Technical Service Bulletin: tsb100261

Released Date: 17-Mar-2004

Spacer Washer for the Harness Mounting

Figure 1, New Spacer Washer Installed

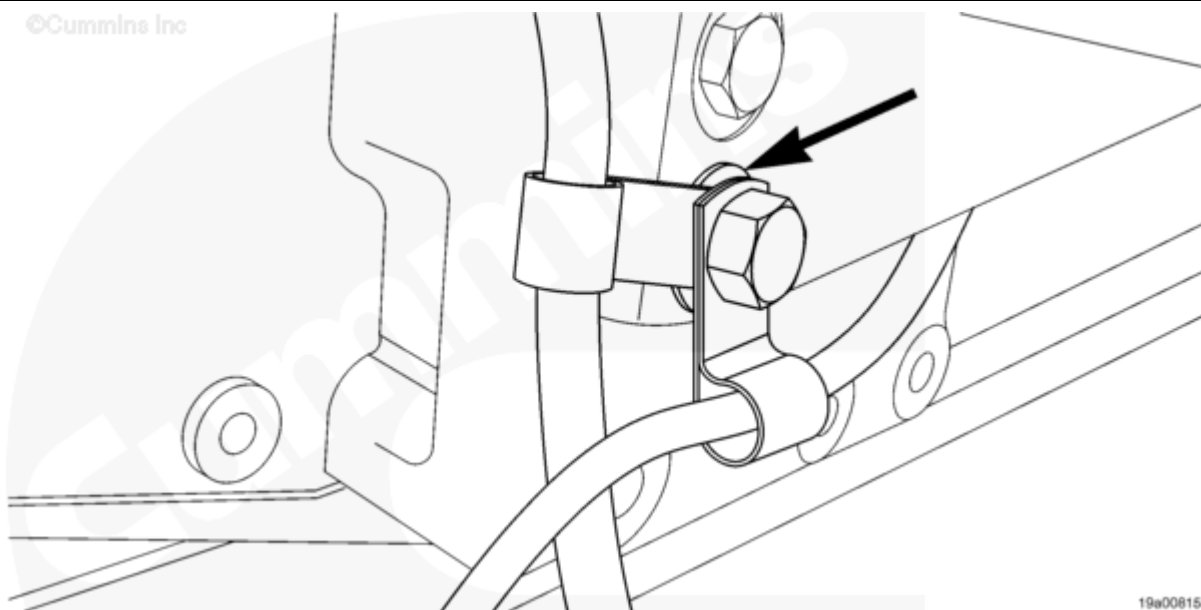
This Technical Service Bulletin announces the addition of a spacer washer under the two P-clips which support the Bosch® EHAB harness wire and the injector fuel return line. The clips are mounted on the left bank fuel pump mount on QST30 series engines.

The washer is needed because the fuel pump mount has a recessed spot face which will bend or fracture the bottom P-clip when the capscrew is torqued.

The washer, Part Number 3094024, will be added to options PH5723, PH5724 and PH5725.
